ADDENDUM II

SUBJECT: Request for Offer (RFO) / Annual Contract for Public Safety Response Vehicles, (6100019666), Scheduled to Close: June 22, 2026; Date of Issue: May 27, 2026

THIS NOTICE SHALL SERVE AS ADDENDUM NO. II - TO THE ABOVE REFERENCED REQUEST FOR OFFER

4.13.1 Applies to BID ITEM 4

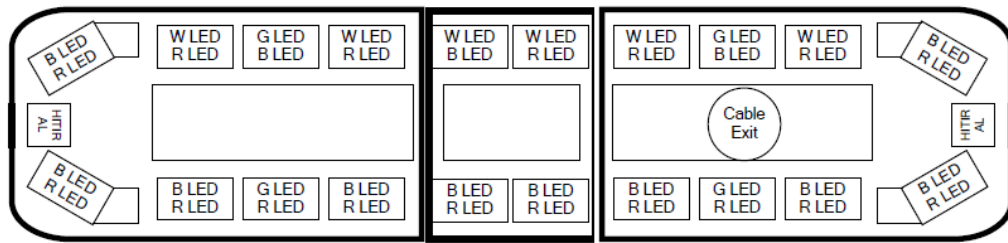
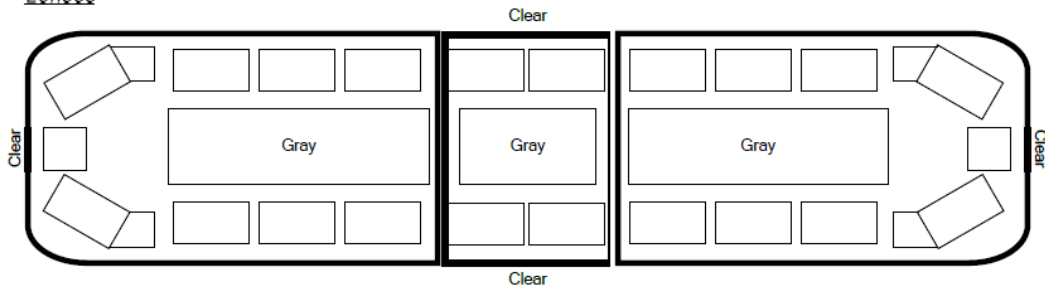
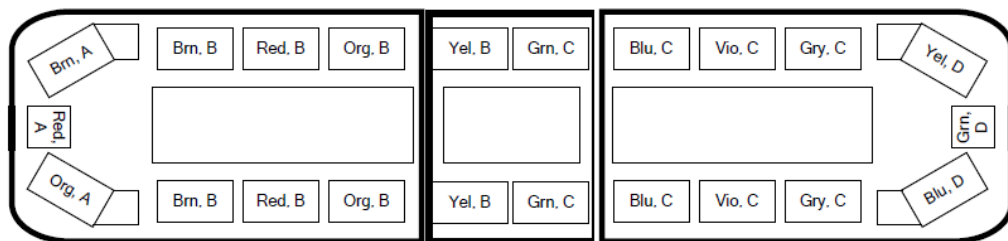
Question 10: Under Bid Items 1, 2, and 3 they do not have any emergency lighting listed, but have lightbar drawing for item 1 (4.13.1). Should there be lighting?

Question 15: Bid Items 1 and 2 do not list a lightbar, controller or siren speakers, but there are references to these items in the lightbar layouts. Can you please verify if these items are needed for bid items 1 and 2?

Response: 4.13.1 is for ITEM 4 (Items 1,2 and 3 do not have emergency lighting needed). Please refer to all updated sections under 4.13.1, 4.13.2, 4.13.3 and 4.13.4.

Response: Lightbar design association has been updated. Items 1,2 and 3 do NOT have lightbars in the specifications. Please refer to all updated sections under 4.13.1, 4.13.2, 4.13.3 and 4.13.4.

4.13.2 Applies to BID ITEMS 5, 7 and 8

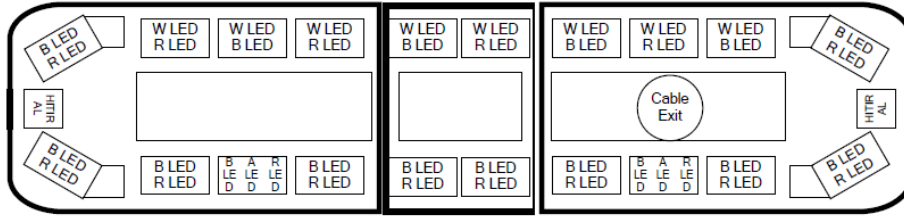
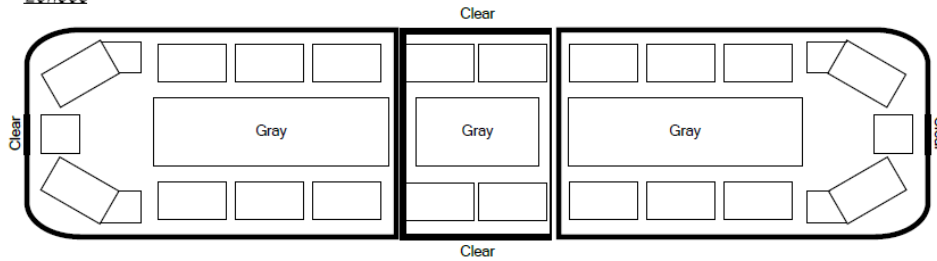
Question 12: Under Bid Item 7, Section 4.9 has a 54" lightbar listed but they have not provided a drawing, which lightbar layout applies? Please update with a lightbar drawing.

Question 13: Under Bid Item 8, Section 4.10 has a 54" lightbar listed but they have not provided a drawing, which lightbar layout applies? Please update with a lightbar drawing.

Response: 4.13.2 is the appropriate design for lightbar of item 7. Please refer to all updated sections under 4.13.1, 4.13.2, 4.13.3 and 4.13.4.

Response: 4.13.2 is the appropriate design for the lightbar for item 8. Please refer to all updated sections under 4.13.1, 4.13.2, 4.13.3 and 4.13.4.

4.13.4 Applies to BID ITEM 9

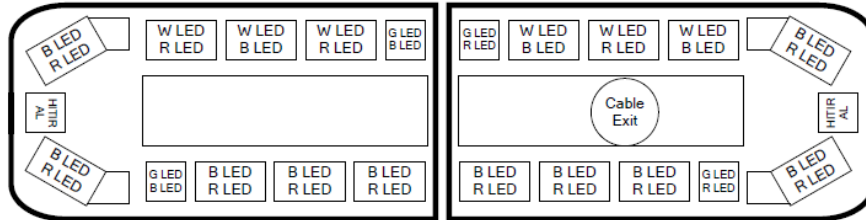
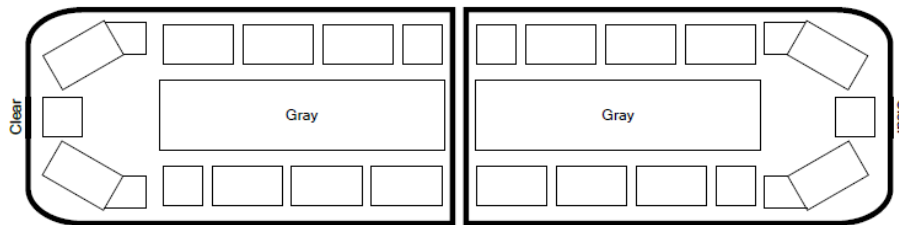
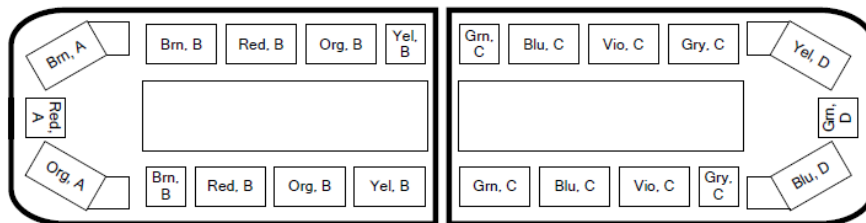
Question 14: Under Bid Item 9, Section 4.11 has a 48" lightbar listed but they have not provided a drawing, which lightbar layout applies? Please update with a lightbar drawing.

Response: 4.13.4 is the appropriate design for the lightbar for item 9. Please refer to all updated sections under 4.13.1, 4.13.2, 4.13.3 and 4.13.4.
